Proposal Request

PROJECT: *(name and address)*
AWSOM
Bentonville, Arkansas

PROPOSAL REQUEST 117

Revisions to Planter Boxes

7 1101 GALLERY RISERS - TYPICAL PLANTER SECTION
1 1/2" = 1'-0"

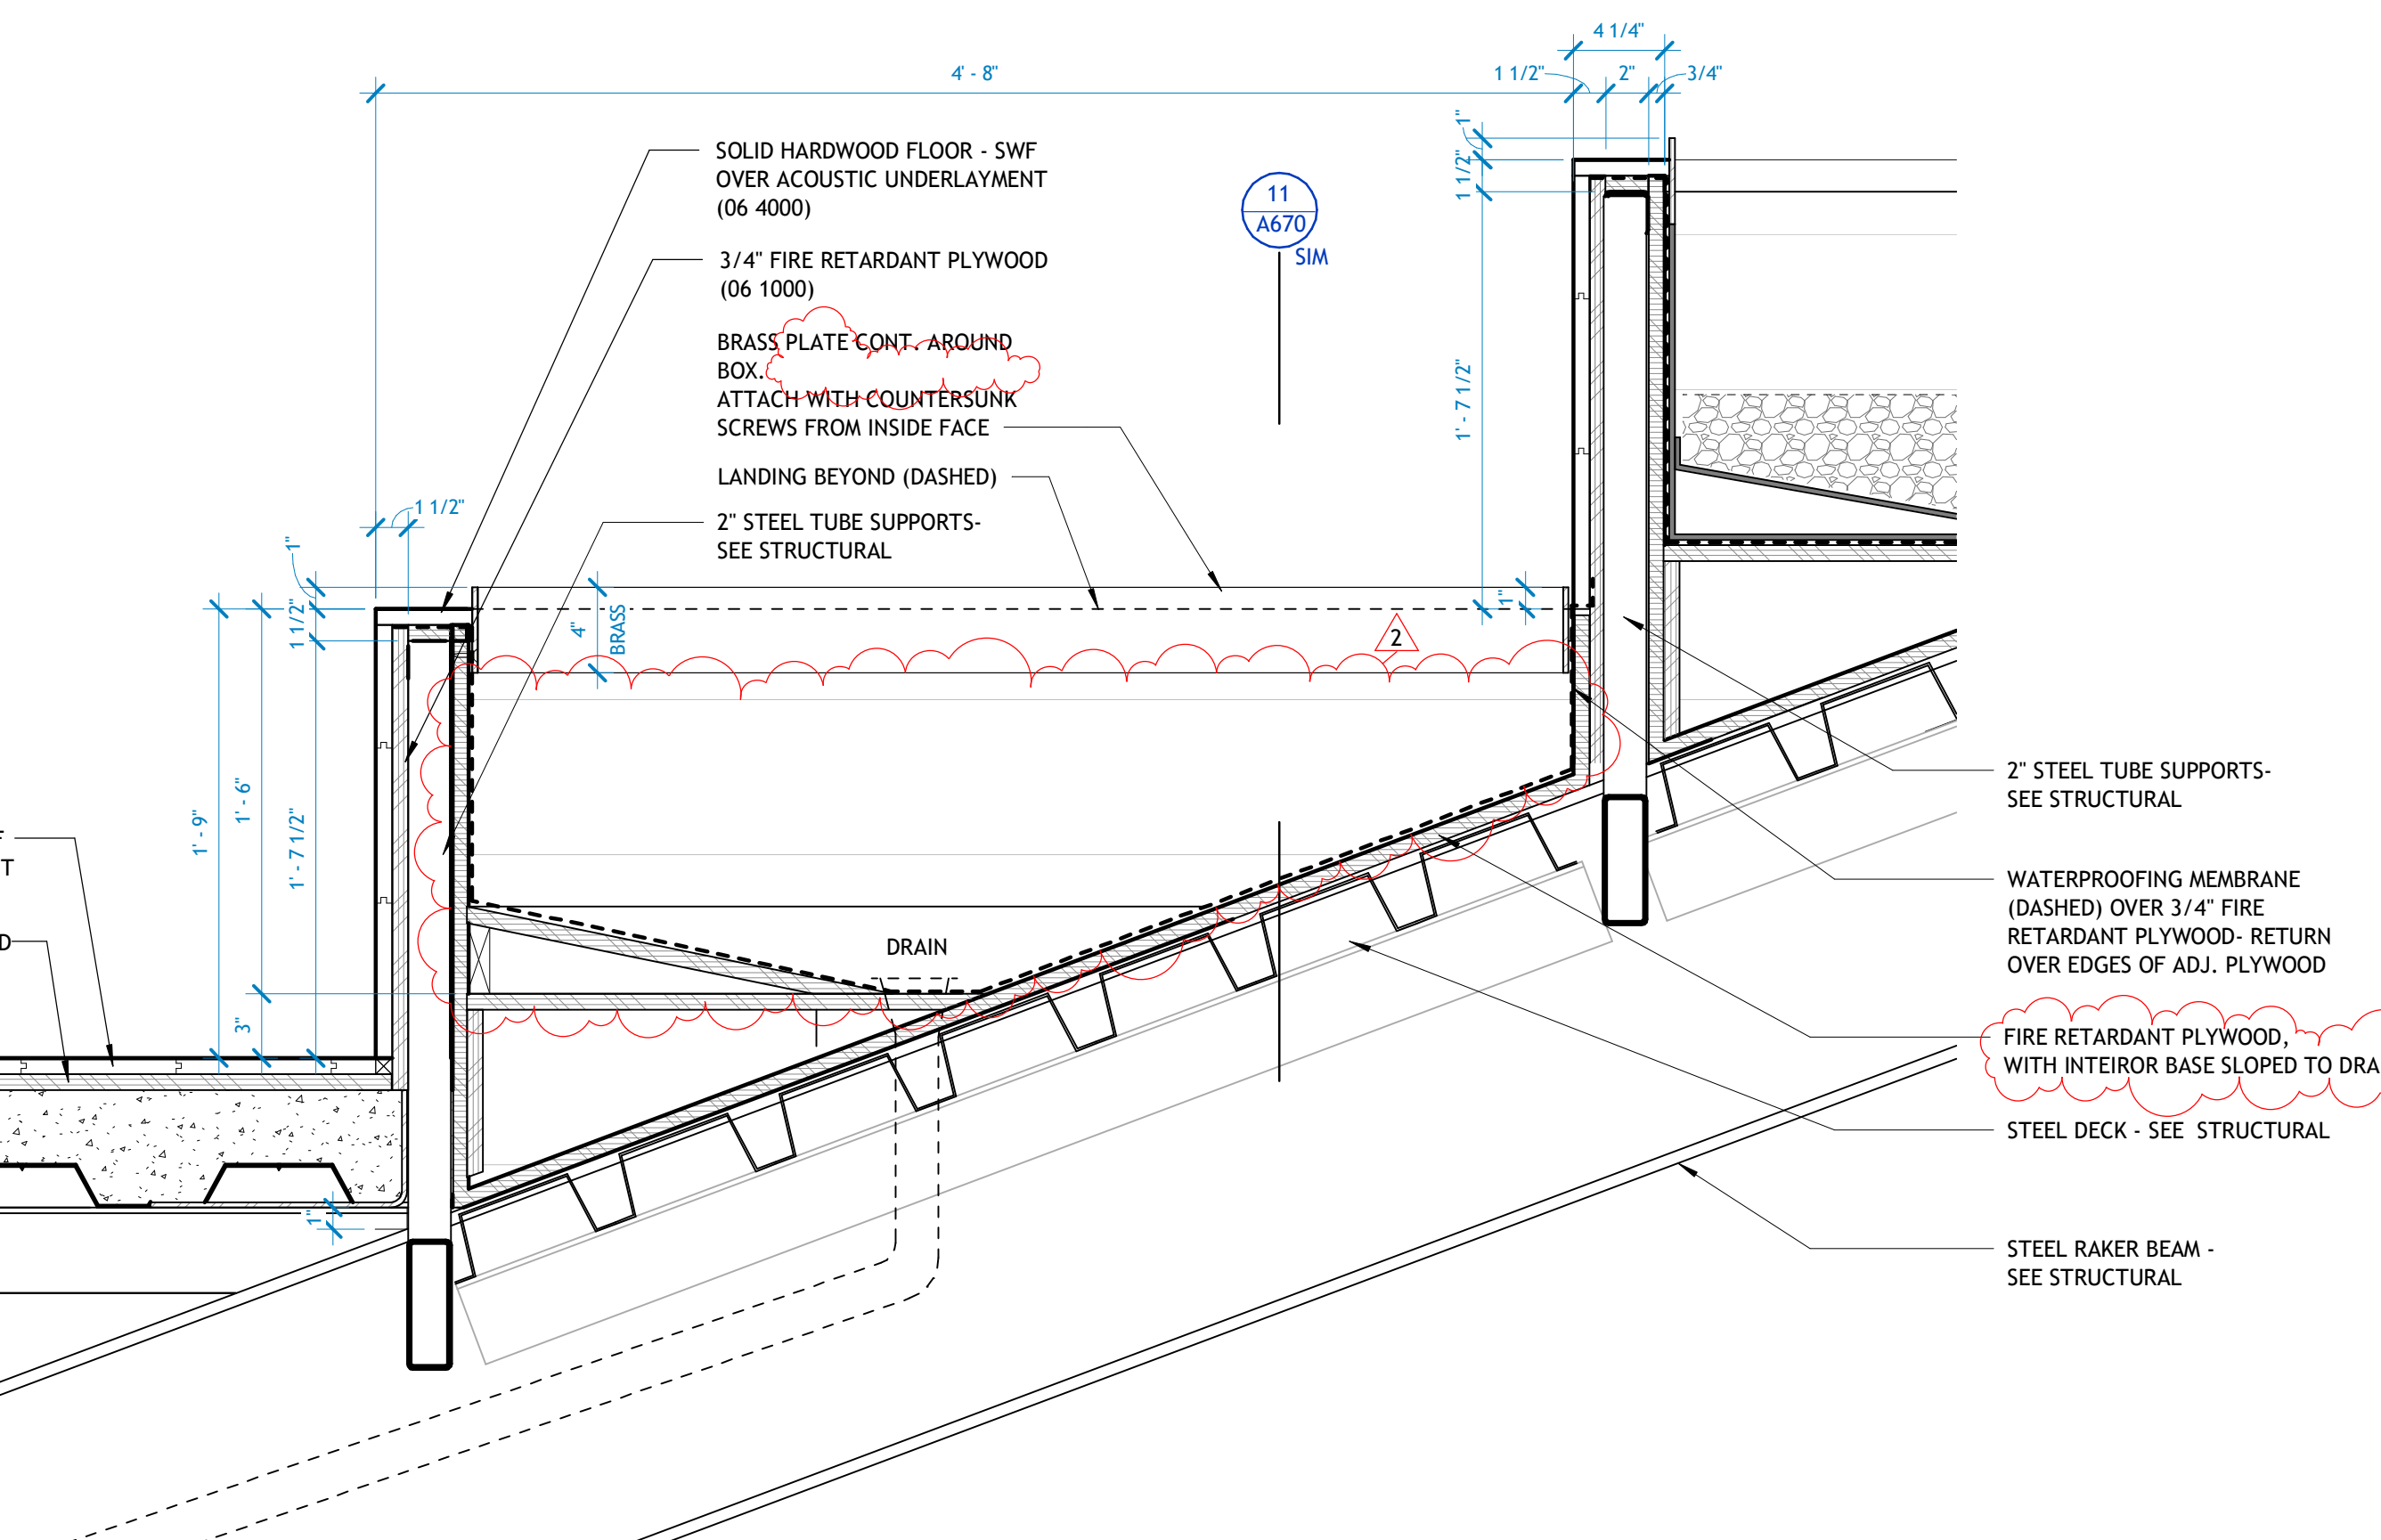
- **DETAILS 7, 9, & 11:**

- (1) Remove steel planter box, keeping brass edge trim as originally designed. Plywood base (fully waterproofed) to slope to drains as shown.
- (2) Remove planting mix and gravel base from within planting area. Owner's plant installer will provide complete planting assembly.
- (3) Brass edge note revised to brass 'plate' in lieu of panel, which matches intent of solid plate edge.
